RE: Chico Creek/ Ueland Tree Farm HMP and Wetland Report Third Party Review

I have prepared the 3rd party review and analysis for the proposed Ueland Tree Farm, LLC's mineral mining application at your request. I was asked to review the documents listed below identifying any comments, questions and discrepancies I find in the files.

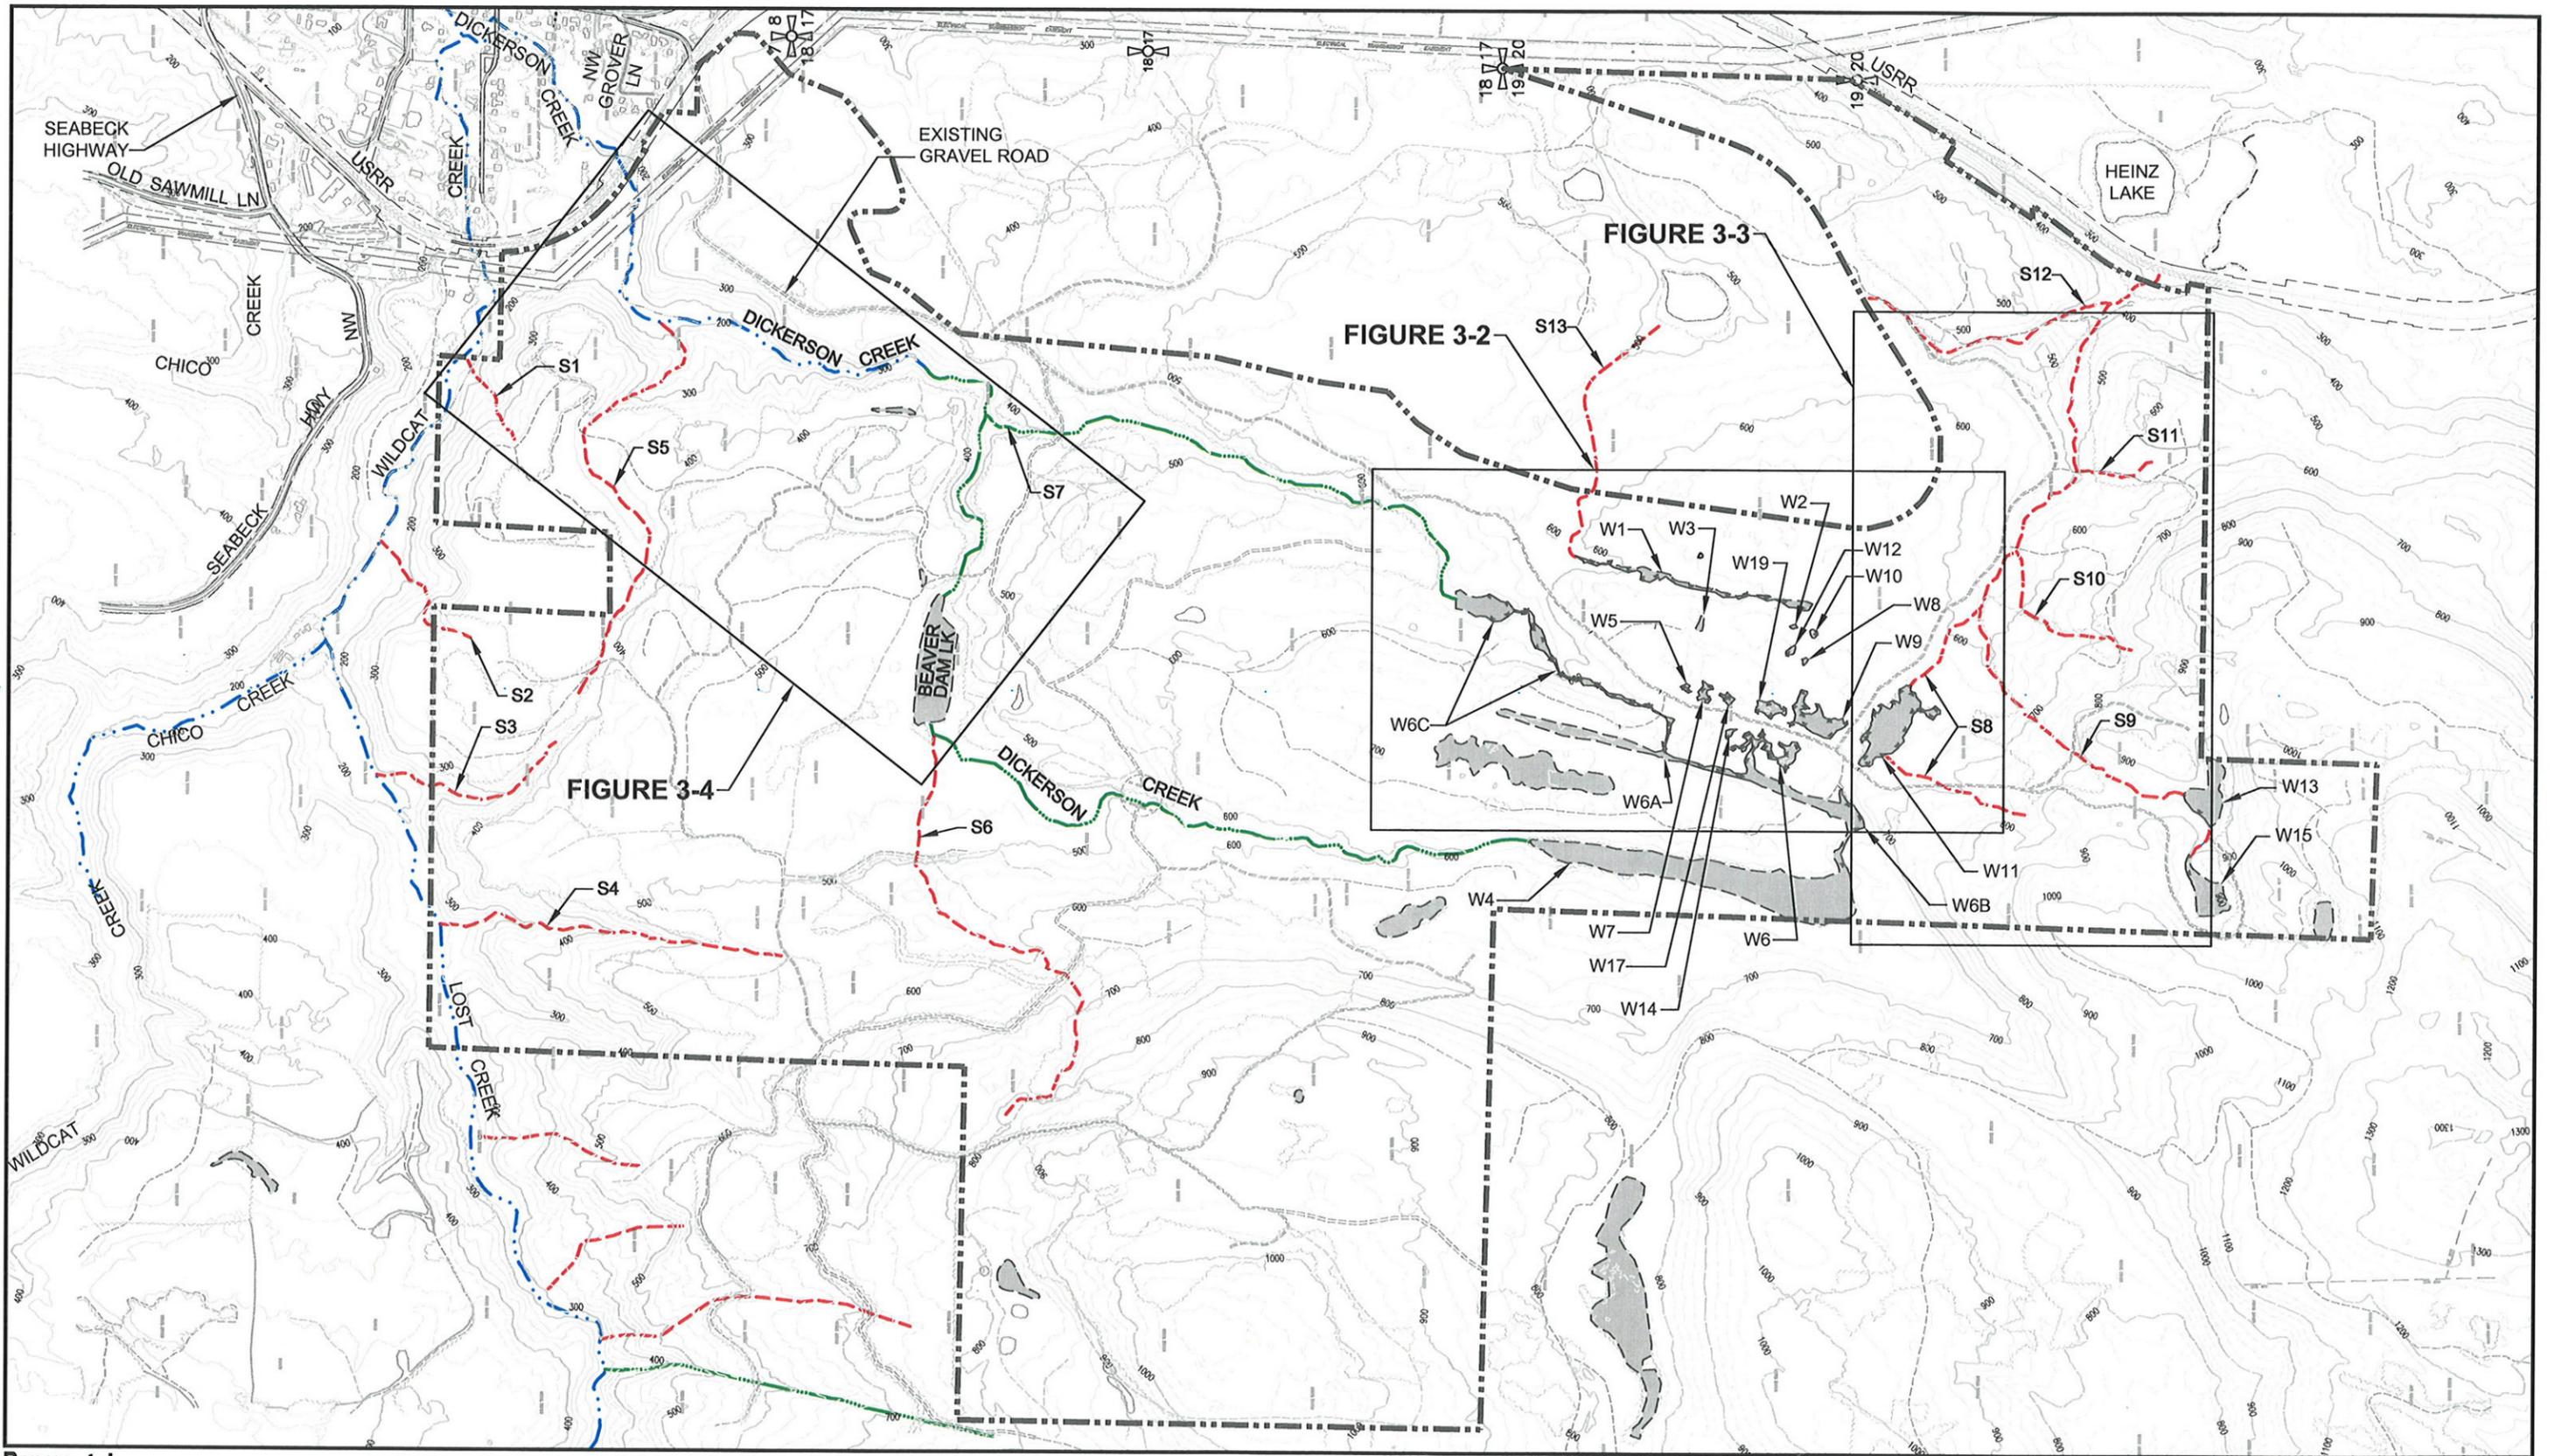
7. Hydrology and Proposed Quarry Stormwater Plan Issues. The proposed Stormwater Plan for the Quarry is shown on sheets C11 and C12 of the *Mineral Resources Development and Preliminary Reclamation Plan* (Parametrix). There are many problems with this plan.

- The discharge points from the mining operations are shown on the approved drainage plans to have discharge points in a southern portion of Wetland 4 (Beaver Pond). This should not have been approved as discharge should only be designed to occur into an upland buffer. Unfortunately, the Geology Report Geo Resources 2015) identifies that there is severe risk of erosion for the soil found in this area (Figure 3), so any discharge design would need to take the soil type into consideration and the design would need provide extra erosion potential, OR, the discharge location would need to be moved to a less erodible soil type. If the discharge is retained within the 200-foot buffer zone, mitigation will need to be provided. None is currently discussed in the mitigation plan (Soundview Consultants, 2014).

- The buffer modifications discussed above would increase the buffer width on Wetland 4 (Beaver Pond) and County would require moving the stormwater pond further south past the 200-foot buffer

- The *Preliminary Drainage Plan* shows stormwater ponds (Q-A, Q-B, and Q-C) that are temporary and the design criteria used is not in compliance with the most current Department of Ecology Stormwater Design Manual (*Stormwater Management Manual for Western Washington*, 2014) and the report specifically states they will not hold a 100-year flood event. Not only is this not in compliance with the DOE design criteria, but these ponds will not protect downstream receiving waters. I see no design changes for these ponds identified in the most recent EIS documentation. I would expect that stormwater ponds to contain a 100-year storm event would be much larger than the ponds currently designed and again. The soils in the area need to be addressed as part of the design because much of area is underlain by severe to very severely erodible soil types.

Figure 2. Wetland 4 - Solving the Confusion -Maps (Leyda 2012)

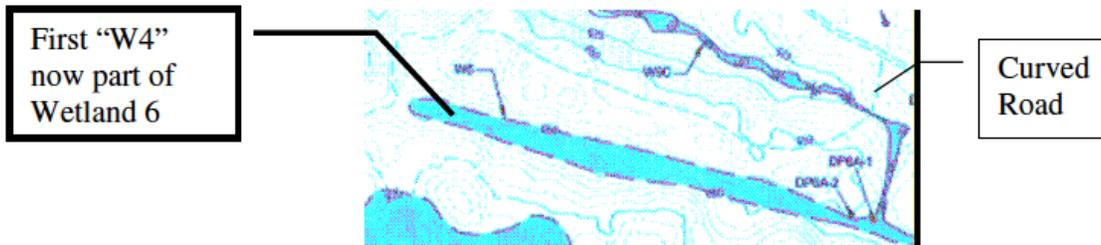
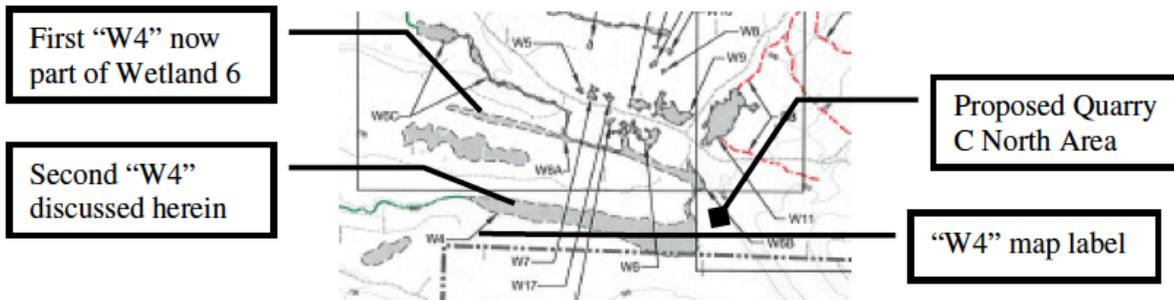
1. Wetland 4, which one? There seems to be some confusion about which Wetland 4 is being assessed and identified in both the reports and during the Kitsap County hearing (2010), the Hearing Examiner's denial of the SEPA Appeal, and the Superior Court dismissal of the Appeal. This wetland is the closest to the proposed mine and so just ignoring this confusion is not an option with respect to understanding potential impacts as a result of the proposed mining project. Leyda in his (6/4/12) report lays out the confusion about Wetland 4 (Figure 2). Initially, Parametrix identified a Wetland 4 that was separate but located at the north end of Wetland 6. Molly Adolfson (ESA, June 2015) stated this was part of Wetland 6 mentioned in the EIS but this is inaccurate there are actually 2 wetland 4's identified in the materials so there is some confusion that persisted in the hearing (Leyda 6/4/12). It is important that the permit application and record accurately reflect the two wetland 4's and resolve the confusion with respect to Wetland Ratings, and buffer assignments.

Leyda Report (6/4/12). First mention of Wetland 4 shows it as a separate wetland but at the north end of Wetland 6.

Leyda Report (6/4/12). The Wetland Delineation Report, Figure 3-2 (Parametrix, [date](#)) shows original Wetland 4 now incorporated into Wetland 6.

Leyda Report (6/4/12). Same Wetland Delineation Report, Figure 3-1 (Parametrix, [date](#)) shows Wetland 6 and a second Wetland 4 (located at the beaver pond in Dickerson Creek) now incorporated into Wetland 6.

Inset 6a. Graphic from DOE Wetland Rating Manual (p. 13, Figure 1) showing theoretical divisions of the same wetland into different rating units (Units 1 and 2a, 2b).

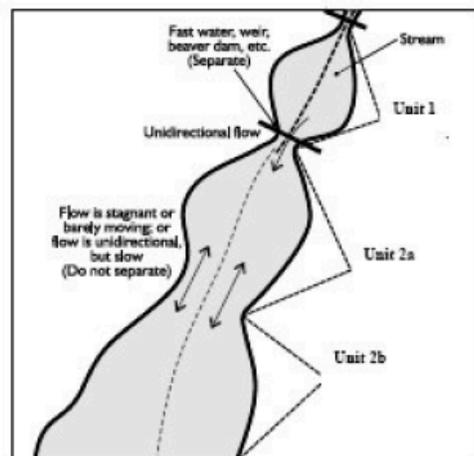
Because of the position of Wetland 4 along the creek, the rating rules for "Wetlands in a Series of 13

Inset 5. Clipped from Habitat Management Plan, Fig. 4-1 (north is to the left). Two tributaries joining offsite from the southwest add considerable flow to Wetland 4.

Inset 6b. Graphic from manual, marked with features from Wetland 4 to illustrate the similarity of Wetland 4 to the graphic. The blue arrow callouts symbolize the water inputs to Wetland 4.

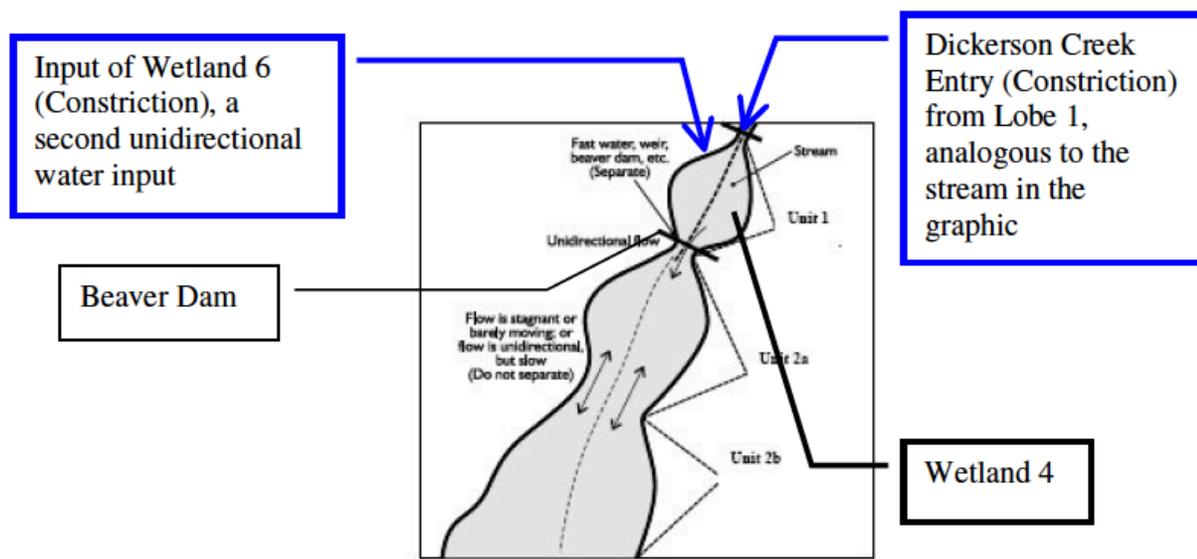
Dickerson Creek has a narrow width formed by natural banks as it enters Lobe 1, then widens into the beaver pond. This change in width from constricted to wide is analogous to the very top of the graphic in Inset 6a.

Wetland 4 was created by a beaver dam in a stream, like the theoretical wetland in the graphic. Wetland 4's configuration matches this theoretical configuration shown in Inset 6a. They both have a beaver dam, a stream in the middle, and a natural constriction at the top where the stream enters (edge of Lobe 2).

In addition to the creek entering through a constriction, Wetland 6 also enters through a constriction as it drains into Wetland 4. Inset 6b shows the theoretical example from the manual marked with the actual site features in diagrammatic form. Imagine the theoretical example with two constrictions on top, one from the creek, and one from Wetland 6. This is the case with Wetland 4.

Inset 8. Approximate location of Lobe 1, and the proposed stormwater discharge to the Wetland 4 buffer, which is very likely in or near the unmapped Lobe 1 of Wetland 4. (Clipped from *Mineral Resource Development Plan*, Sheet C11).

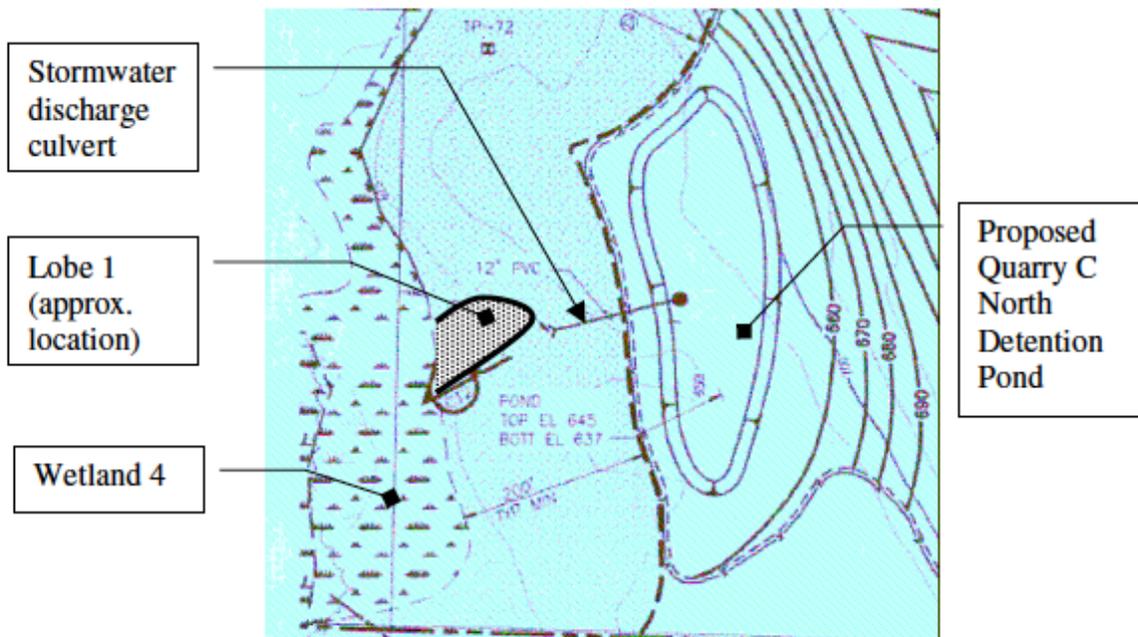
The opportunity to improve water quality will exist after the proposed quarry construction, since the proposed Quarry C North detention pond is shown to discharge to a topographic low point in the Wetland 4 buffer about 120' from the edge on the map (Mineral Resource Development Plan, Sheet C11). In reality, that topographic low point is either in or very close to the unmapped Lobe 1. Because 50% of the stormwater will be untreated (see F. Wetland 4 Hydrology and Proposed Quarry Stormwater Plan, and because the rating manual says even treated stormwater is polluted, Wetland 4 will have the opportunity to improve water quality after construction.

Although the Construction Notes on Sheets G2 says that deviations from the plan may be necessary (from the general Erosion & Sediment Control Notes, Note 6), which means the exact culvert discharge point could deviate from the plans, the topographic low point will not change, and the stormwater will flow to that topographic low point which could be lobe 1 of Wetland 4.

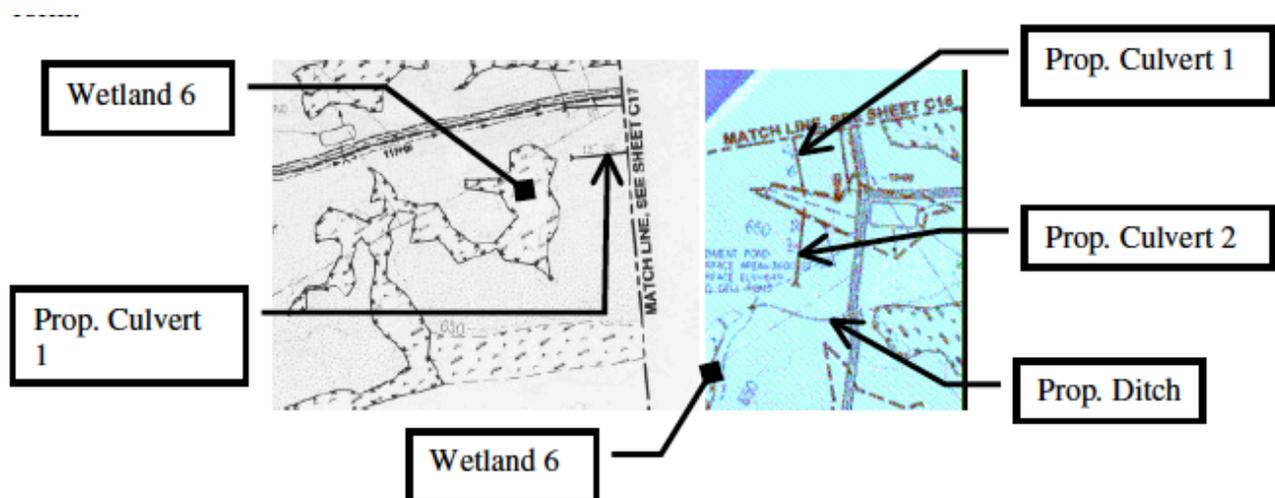
“Soil examined in the southern portion of the wetland (DP W6-1) consisted of a black (10YR 2/1) muck with organic debris to a depth of eighteen inches. In the middle of the wetland (DP W6A-1), soil examined here consisted of a black (10YR 2/1) mucky loam with few, small and prominent dark yellowish brown (10YR 5/8) mottles to a depth of twelve inches. Below this horizon was a very dark grayish brown black (10YR 3/2) silt loam with few, medium-sized and prominent dark yellowish brown (10YR 4/6) mottles. Organic streaking was noted in the lower horizon of this soil profile. At the northern end of the wetland (DP W6C-1), a black (10YR 2/1) sandy muck was observed to a depth of eighteen inches. This horizon had strong brown (10YR 5/8) mottles that were few, fine and distinct. Hydric soil indicators include high organic content in the surface layer, low chroma matrix colors, and redoximorphic features.” (p. 3-20).

So, the box on the rating form for Question D1.2 should be checked “Yes,” and four points added to the score. This addition will make the “Total for D1” box read 15 points instead of 11 points.

Question D2 asks if the Wetland 6 has the opportunity to improve water quality. The recorded answer is “no”. The correct answer is “Yes” , for similar reasons that Wetland 4 has the opportunity to improve water quality discussed above. Wetland 4 and most of Wetland 6 are in the same drainage basin (see inset 6) and will experience similar reactions to the same pollution sources. Wetland 6 has the opportunity to do the same water quality improvement because of clear-cut logging in the basin to the south, and has the opportunity in the past based on the previously cut area to the east, (see inset 7).

Like Wetland 4, the opportunity will exist for Wetland 6 to improve water quality after the proposed quarry and road construction, since the proposed roadside detention pond is shown to discharge to a topographic low point in the Wetland 6 buffer (Mineral Resource Development Plan, Sheets C20 and C21), and will likely cause stormwater to enter the wetland. Because 50% of the stormwater will be untreated (see F. Wetland 4 Hydrology and Proposed Quarry Stormwater Plan herein), and because the rating manual says even treated stormwater is polluted (p. 45, comment 38), Wetland 6 will have the opportunity to improve water quality after construction. All wetlands receiving treated and untreated stormwater from the proposed roads will also have the opportunity to process pollutants, so the post-construction ratings may change for any wetland that currently does not have the opportunity box checked on its respective rating form.
